Addendum 01

DOCUMENT 00 91 00

PROJECT: Clermont County Facilities Phase 2 Management Building
State Route 222
Batavia, OH 45103

This addendum form is a part of the Contract Documents and modifies the Construction Documents dated February 19, 2026, with amendments and additions noted below.

A2.1

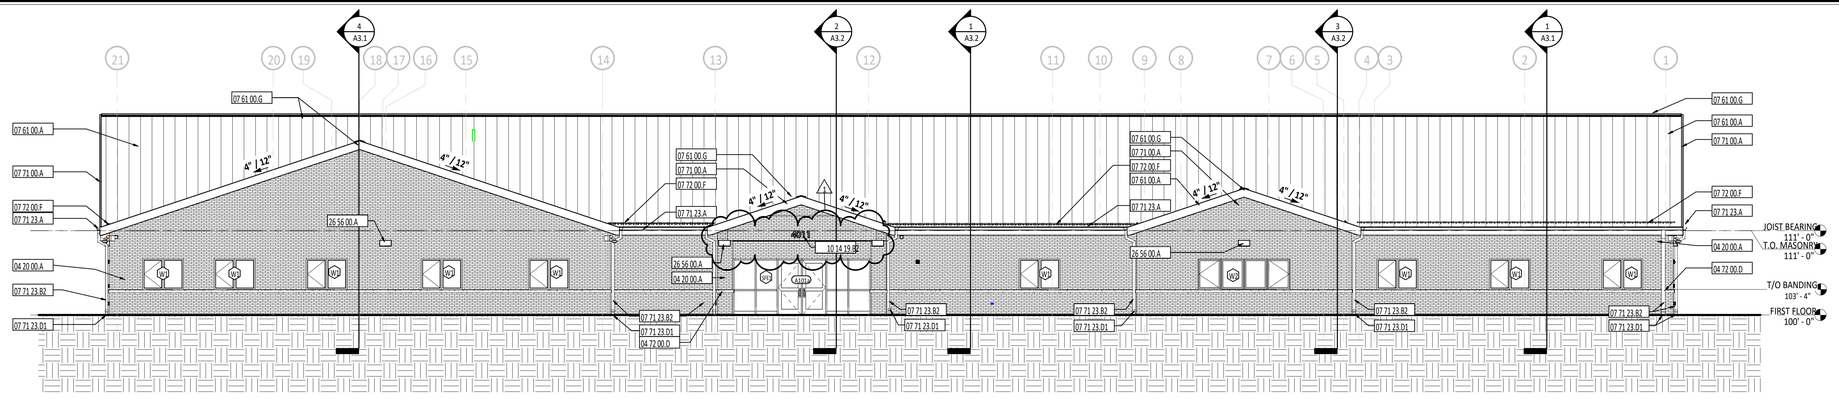
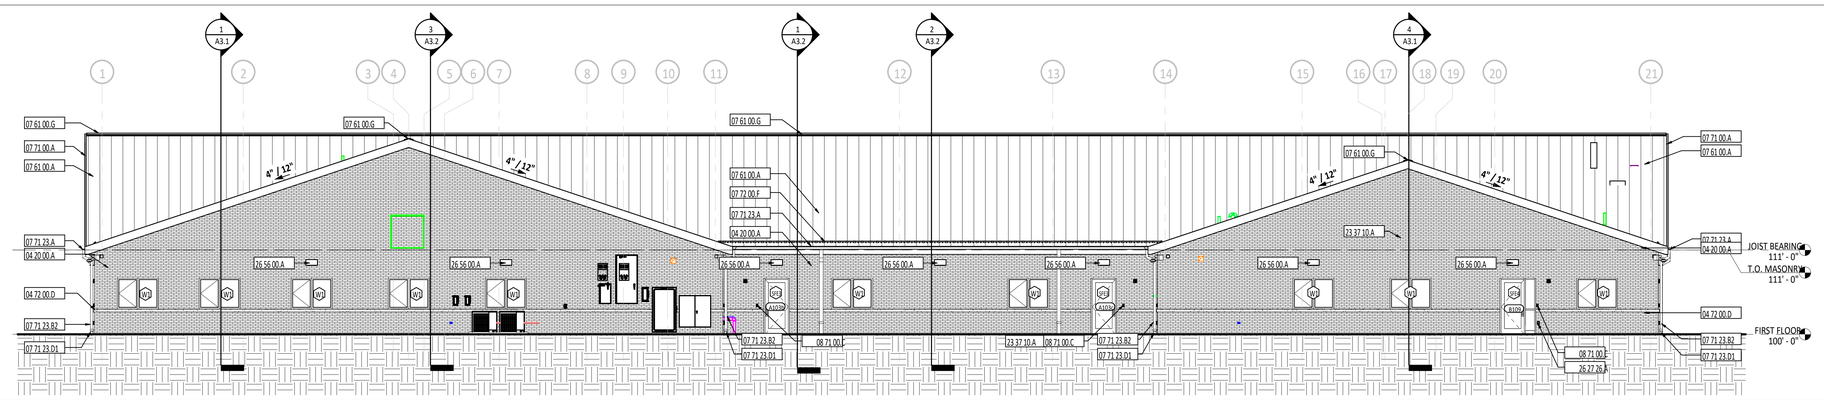
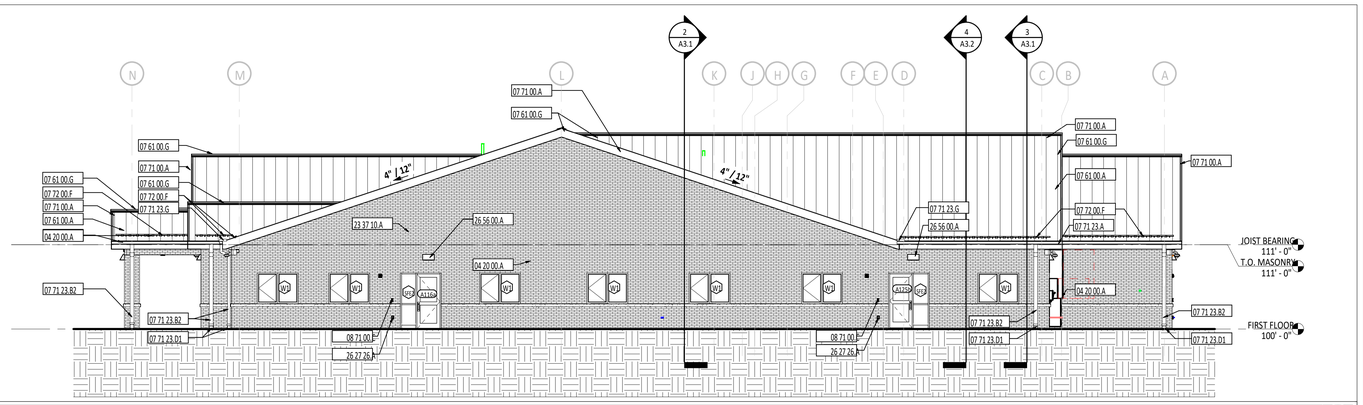
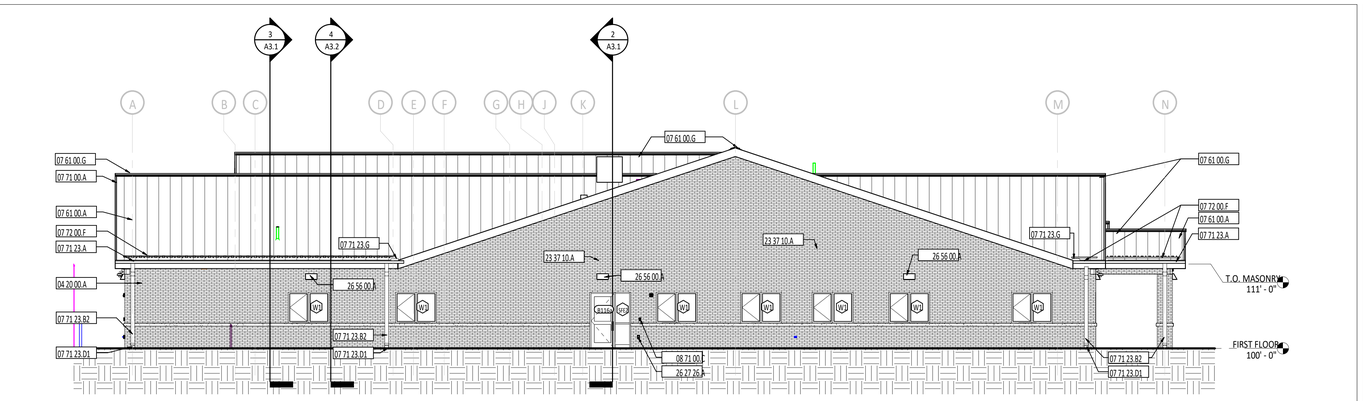
6. Drawing Sheet A2.1 Building Elevations – Overall Exterior – Add building address signage.
7. Drawing Sheet A3.2 Building Sections – Added ceiling in Tech Room A105.

3 / A4.2 TYPICAL FOUNDATION DETAIL
1 1/2" = 1'-0"

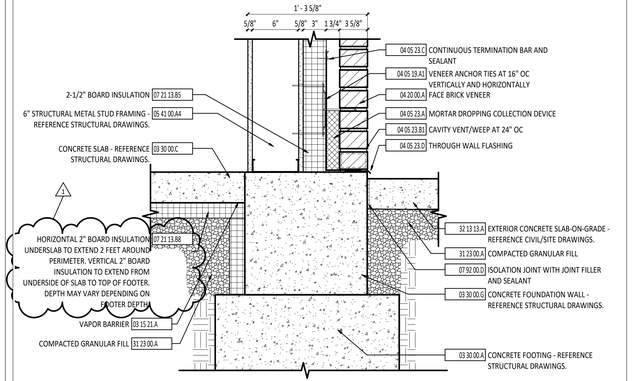
8. Drawing Sheet A4.2 Section Details – Under slab clarification added to Detail 3. Removed continuous air barrier system from Detail 1. Board insulation to provide continuous air and vapor barrier.

1 / A5.1 ROOF PLAN
1/8" = 1'-0"

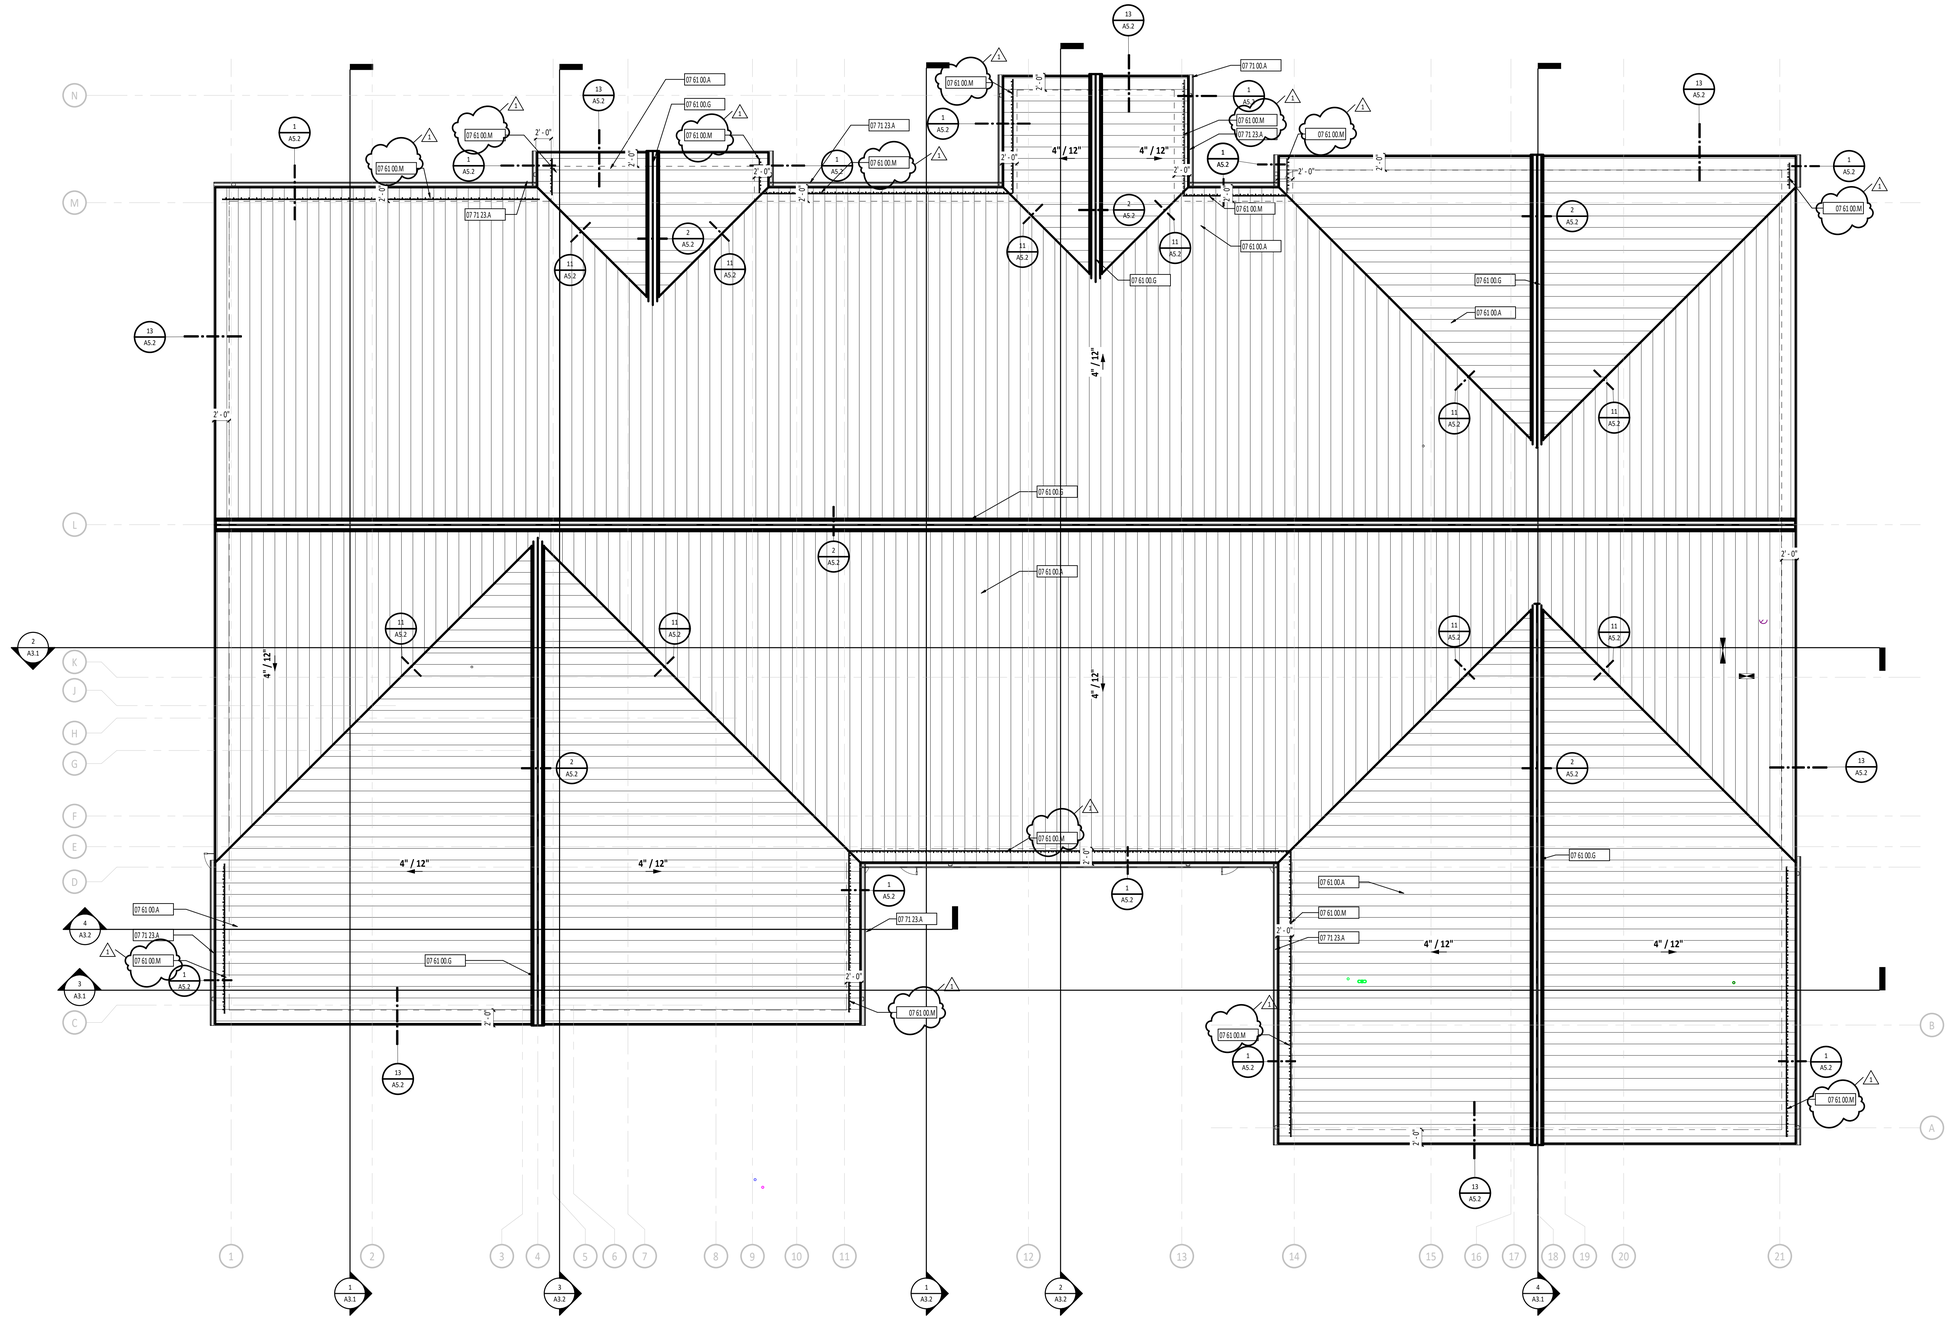
9. Drawing Sheet A5.1 Roof Plan – Coordinated correct spec section on drawings to align with snowguard spec section.
10. Drawing Sheet A6.1 Door Schedule, Door and Window Details – Switched door B120 to B117 to eliminate duplicate. Updated Doors A106a and B101 to be FG2 Door Type.

1 A7.1 FIRST FLOOR REFLECTED CEILING PLAN

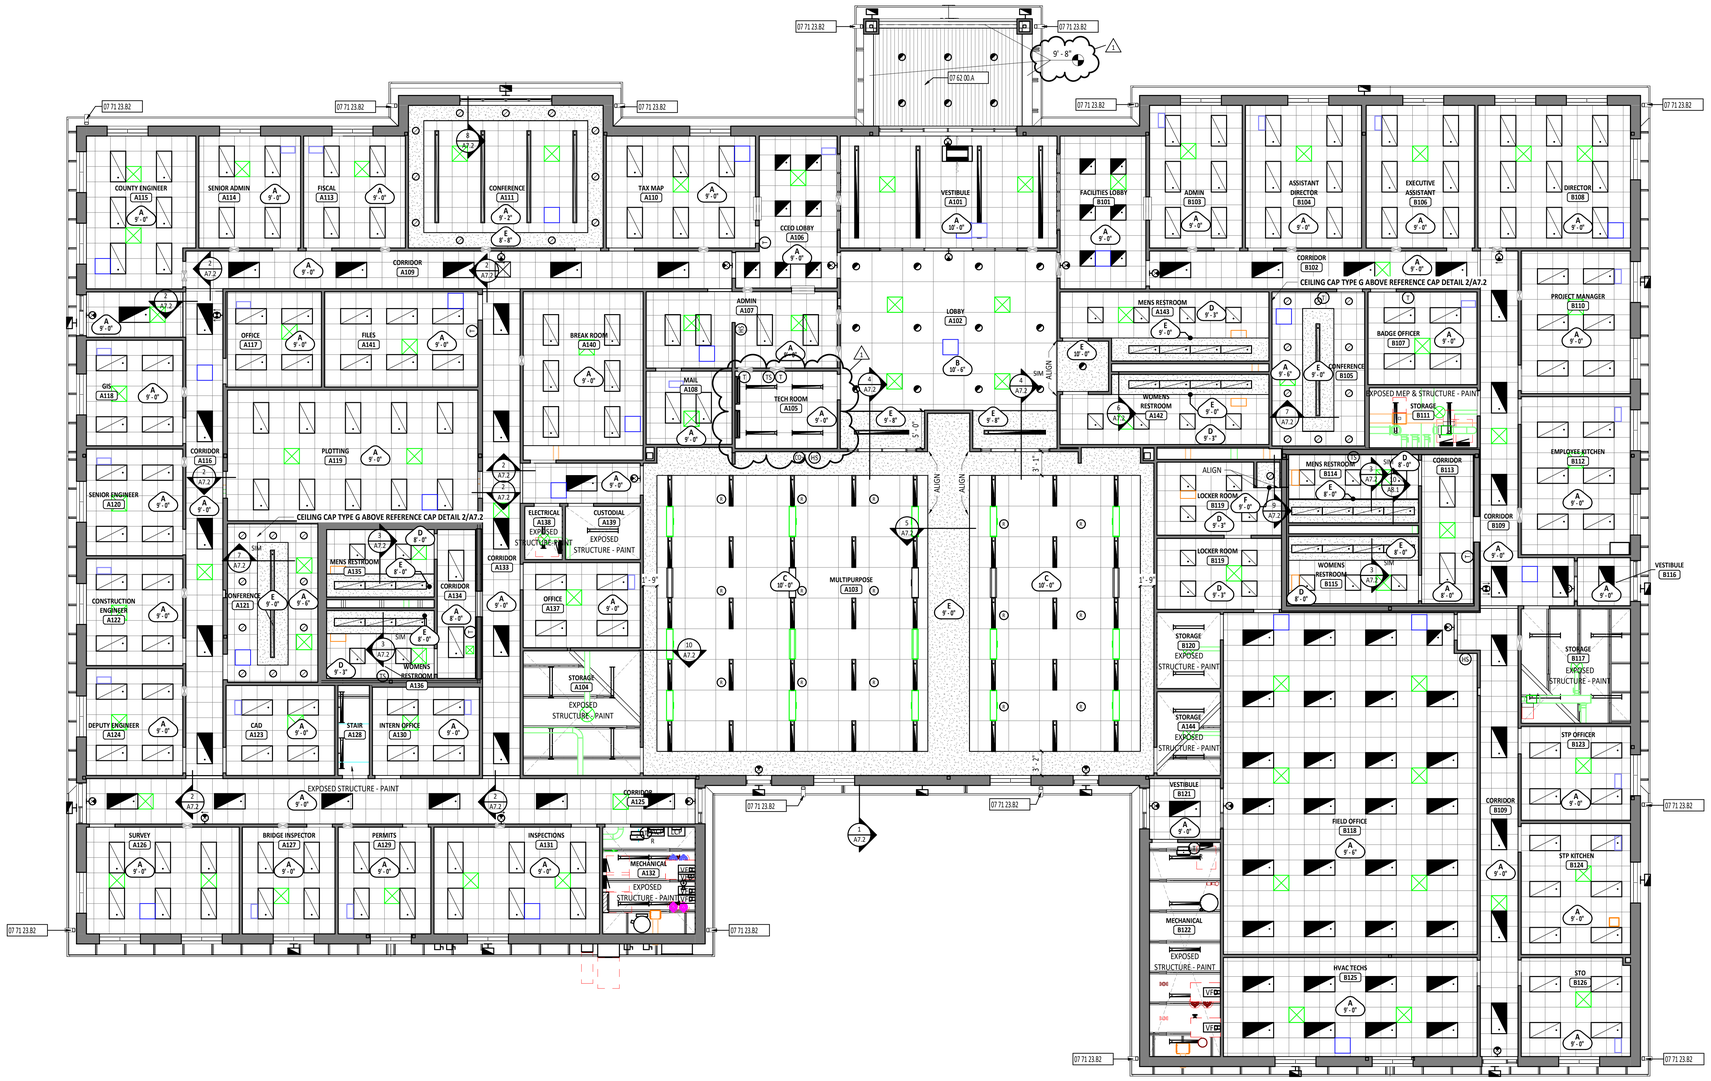
11. Drawing Sheet A7.1 First Floor Reflected Ceiling Plan – Add elevation tag at building soffit, Added ceiling in Tech Room A105.
12. Drawing Sheet M5.3 Mechanical Schedules and Details – Add remark in schedule for isolation pads.

1 / E4.1 LIGHTING PLAN
1/8" = 1'-0"

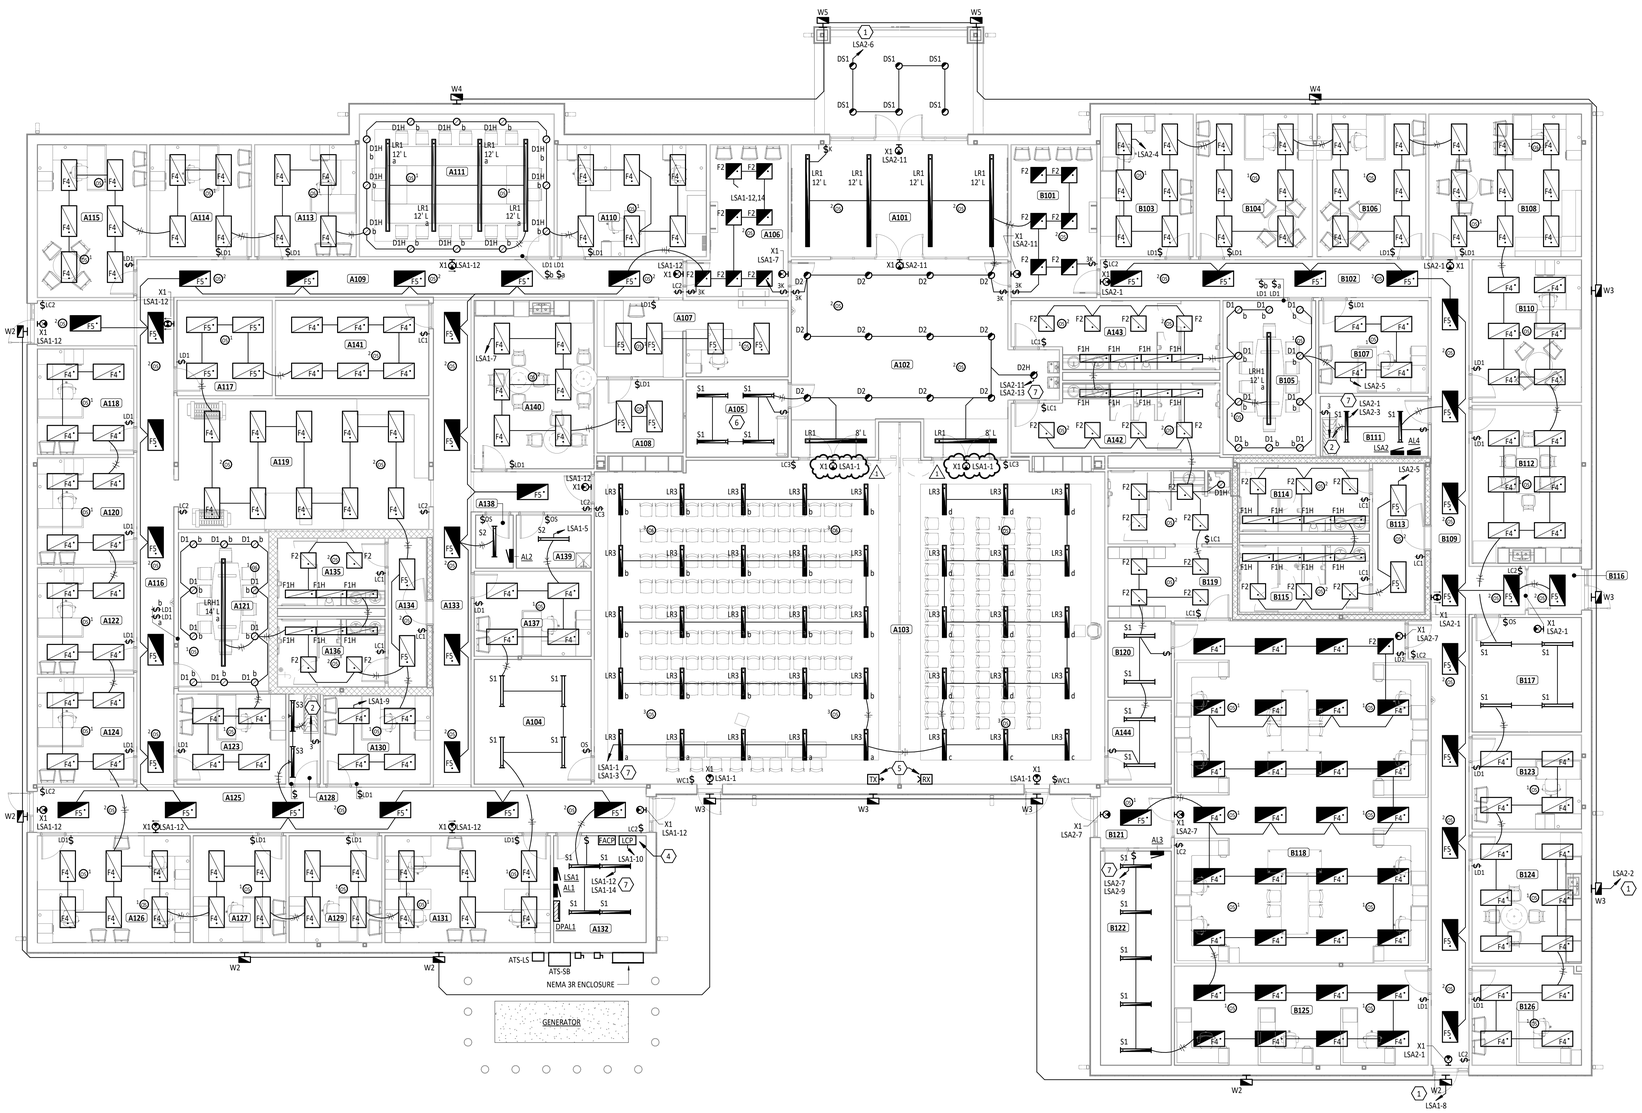
13. Drawing Sheet E4.1 Lighting Plan – Add (2) exit signs 'X1' in room A103.
